Planning & Zoning Board Meeting

October 26, 2023 at 6:00 PM

- 2.** Consideration and Approval: **Elevation Approval - 559 Via Bella Ct.**
- 3.** Discussion: **Comprehensive Plan Evaluation and Appraiser Review (EAR) Process**

TO: Howey-in-the-Hills Planning Board
CC: J. Brock, Town Clerk
FROM: Thomas A. Harowski, AICP, Planning Consultant
SUBJECT: Dreamfinder Homes House Design Waiver
DATE: October 11, 2023

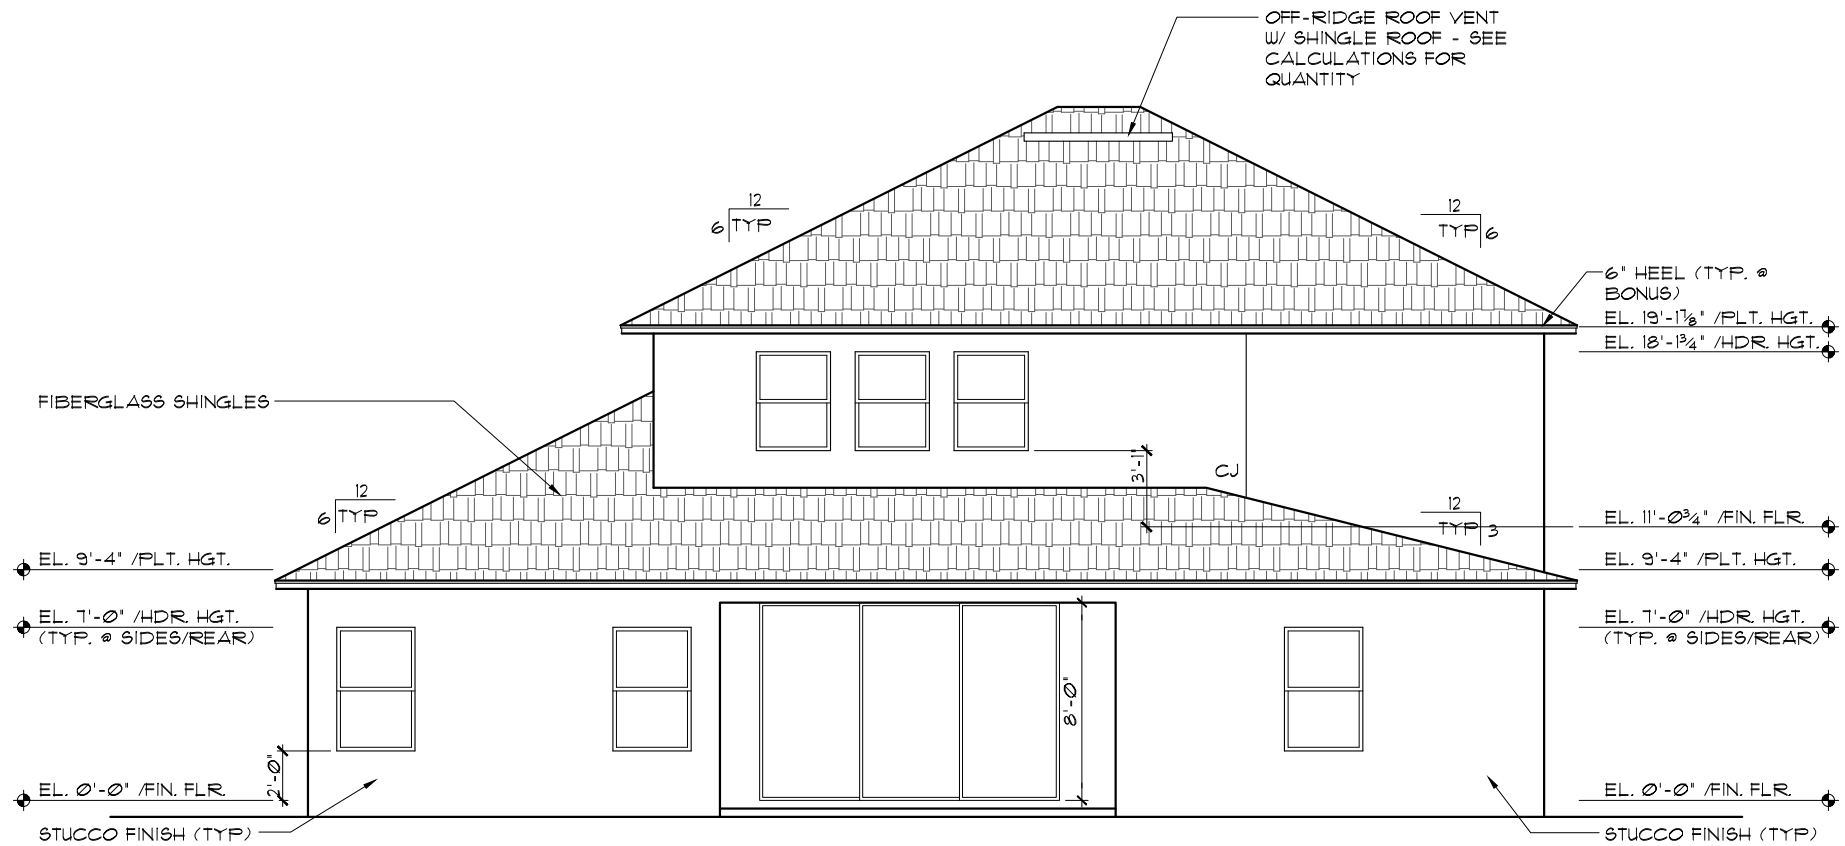
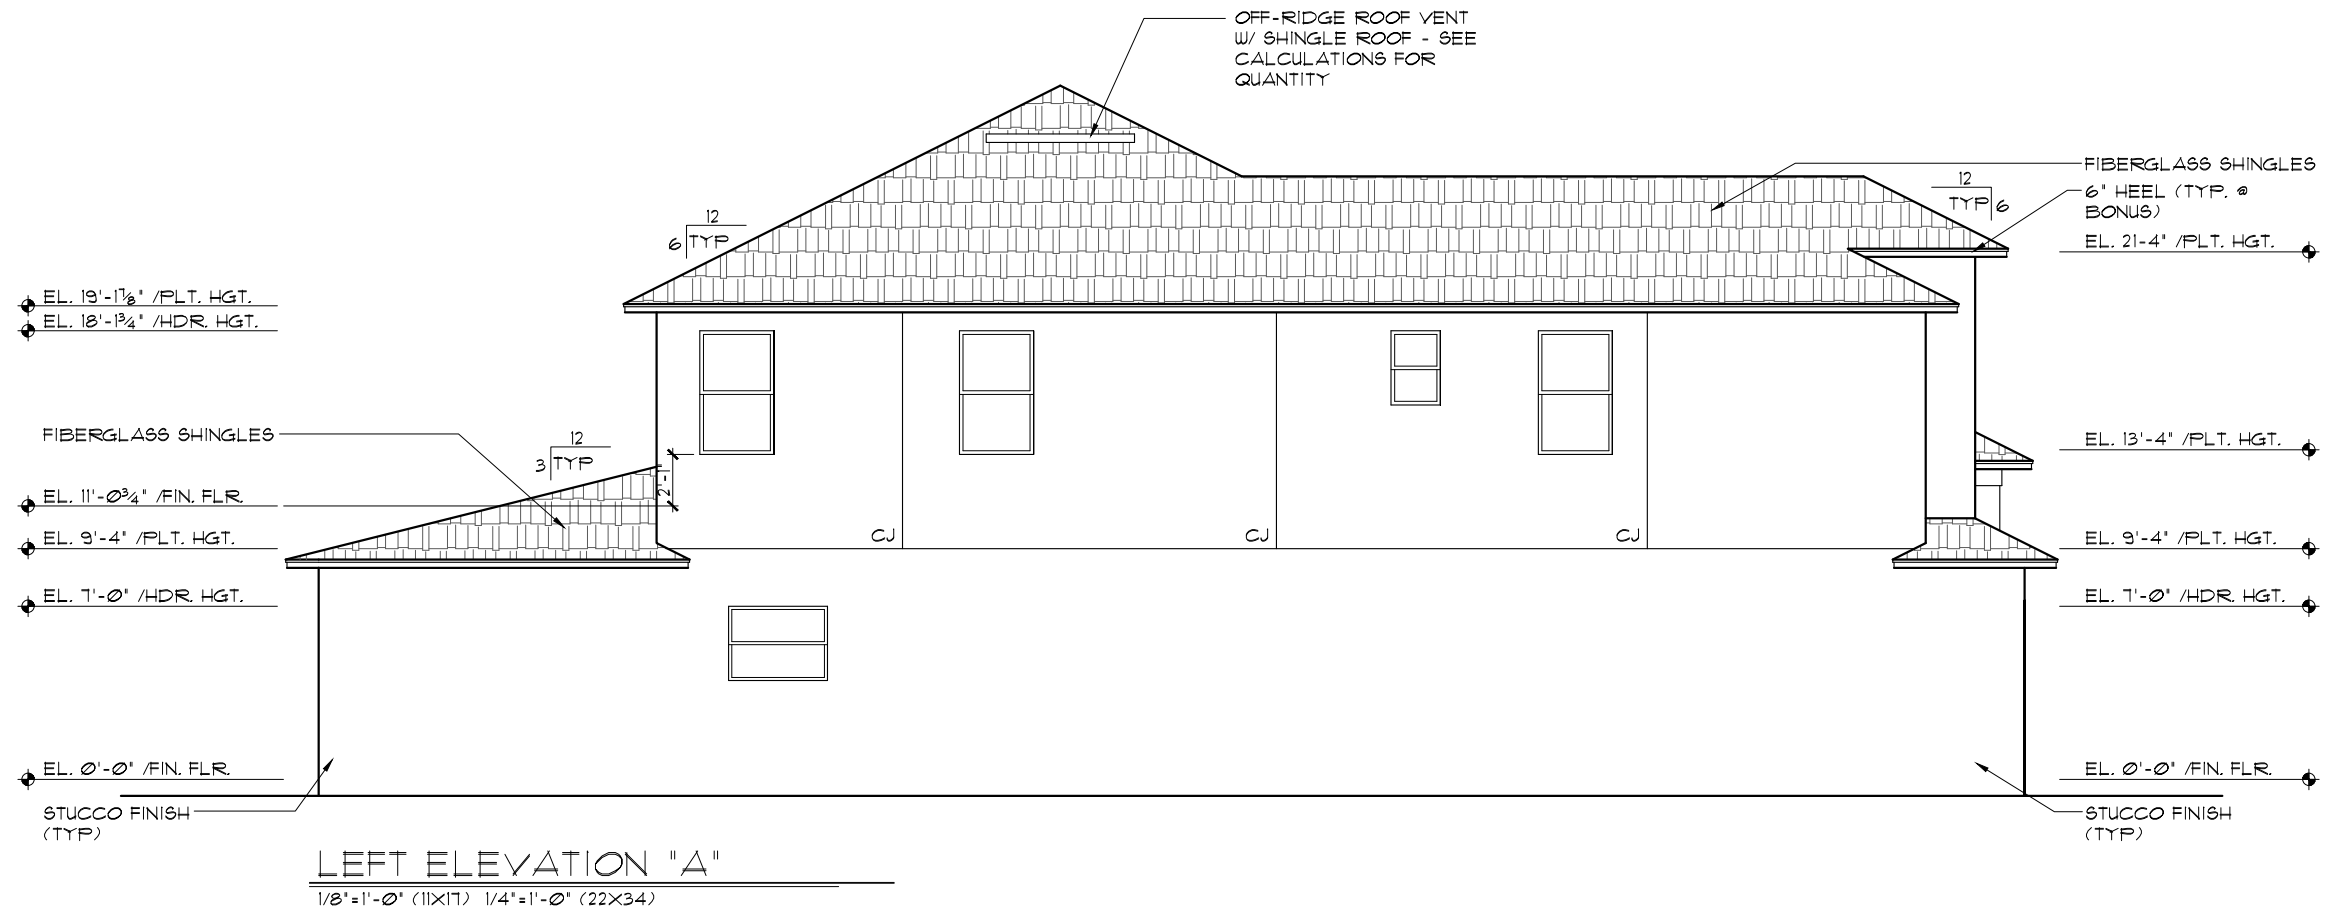
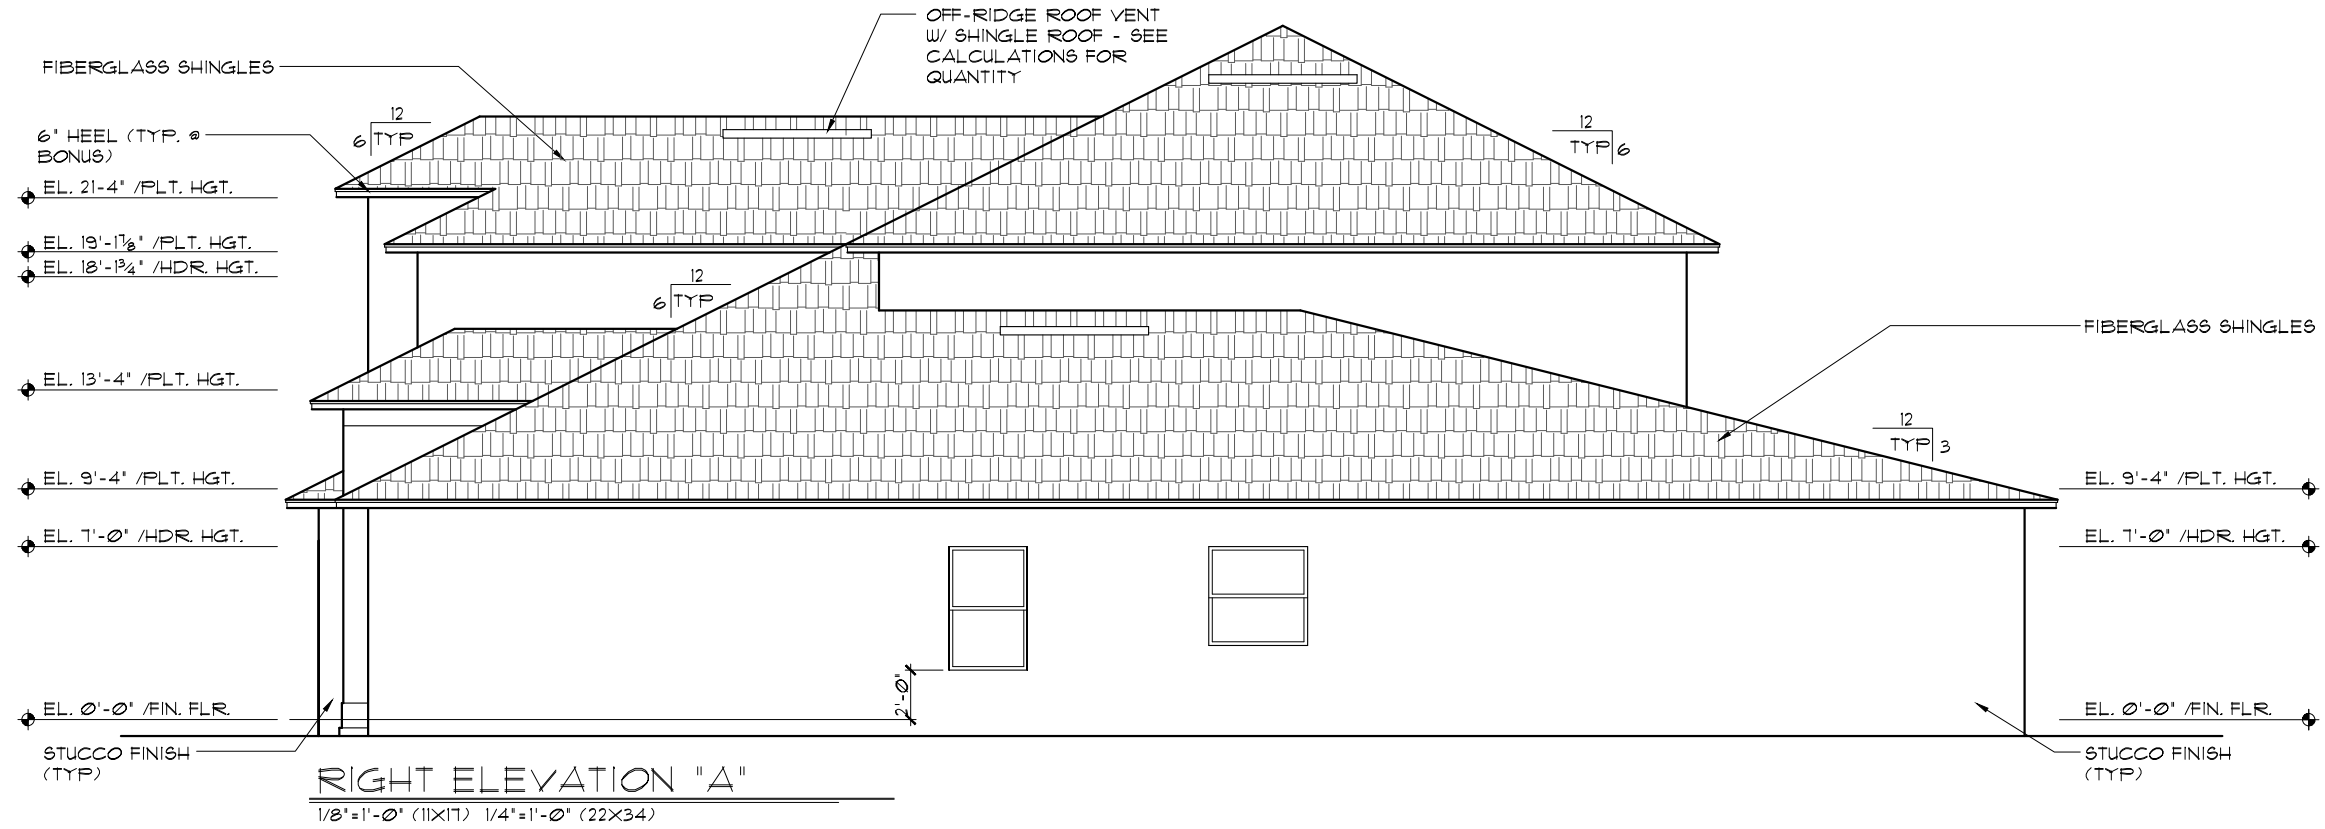
Please see the attached review and comment from the applicant. Would the "flipped" elevation and addition of decorative stone meet the intention of the cited section from the approved developer's agreement? The "2945 AVALON W/BONUS (A)" model is proposed on lot 95. The "2945 AVALON W/BONUS (A)" model was approved on the abutting lot (94) back in April.

Lot 94 has stone added to the elevation and this lot (95) does not. Although the elevations are the same does this actually still violate the monotony rule since one has stone and the other does not?

The purpose of this provision is to allow for full development of the subdivision when few lots are left and the range of house model options is restricted by prior design choices. The waiver allows a prospective homeowner to purchase his desired unit when there may not be another viable option in the subdivision. It also helps the builder complete the subdivision. The only criterion for granting the approval for the added design is that the subdivision be within the final 10% of the lots available for construction. Staff recommends approval.
